Tote, Inc.’s Response to the National Cargo Bureau, Inc.’s “Report on Review of Cargo Securing Manual and Cargo Stowage and Securing” dated August 4, 2016

On August 9, 2016, the National Transportation Safety Board (“NTSB”) posted on Accellion a report produced by the National Cargo Bureau, Inc. (“NCB”), dated August 4, 2016, and entitled “Report on Review of Cargo Securing Manual and Cargo Stowage and Securing” (“NCB Report”).

BAY 14A

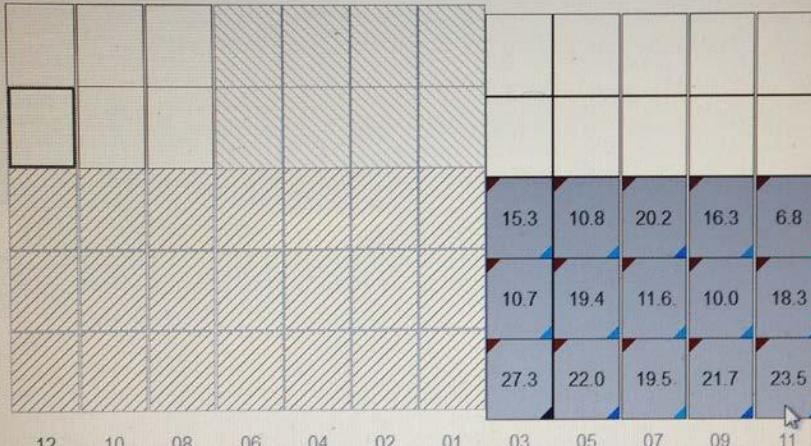
[#] The NCB Report contains CargoMax lashing margin calculations for the alleged exceedances, but these were not include in the Report for Bay 14A.
